New Revisions made 02/09/2025: Changed layout of power distribution from the 12 to 5 volt converter.

The system design is divided across two separate PCBs: one dedicated to power distribution and the other to the microcontroller. This separation provides electrical isolation between the DC power and AC power domains, enabling safe and effective motor control. The Raspberry Pi Pico W microcontroller communicates with the central hub using the MQTT protocol, facilitated by the ArduinoHA library. This allows the device to be controlled through the Home Assistant (HA) web interface.

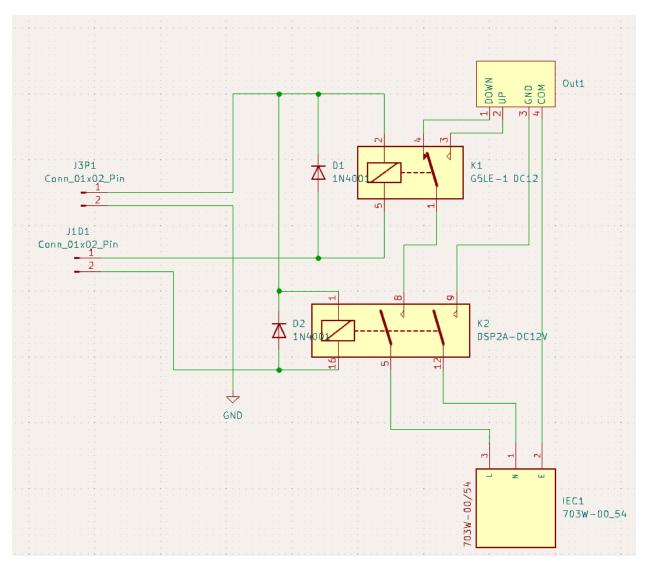
New revisions made 02/12/2025: Adjusted resistors to one schematic from the other, switched transistors, and fixed schematic layout. The resistors in this schematic are as follows: R1=180k, R2=200k, R3 & R4 = 10k.

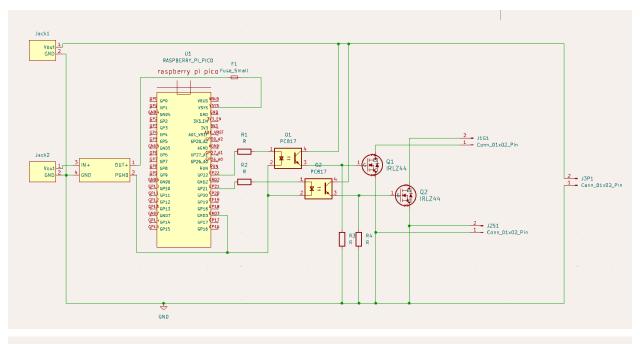
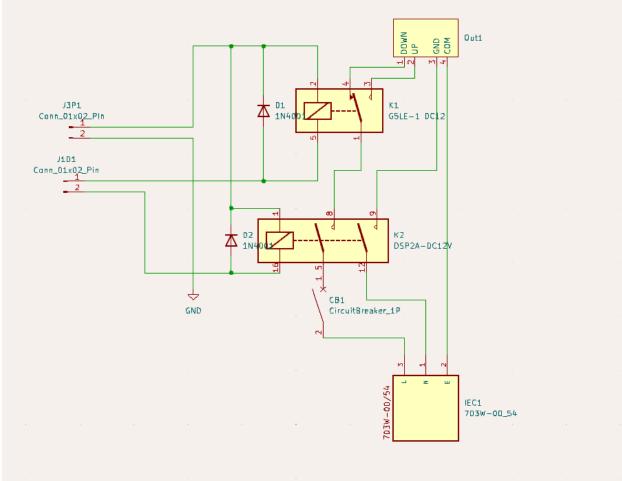
New revisions made 02/15/2025: Adjusted placement of resistors and their values as follows: R3=180k, R4=200k, R1 & R2 = 10k. Also, implemented fly back diodes to prevent unwanted voltage spikes.

New revisions made 04/15/2025: Implemented fuse and circuit breaker to abide by safety regulations and concerns.
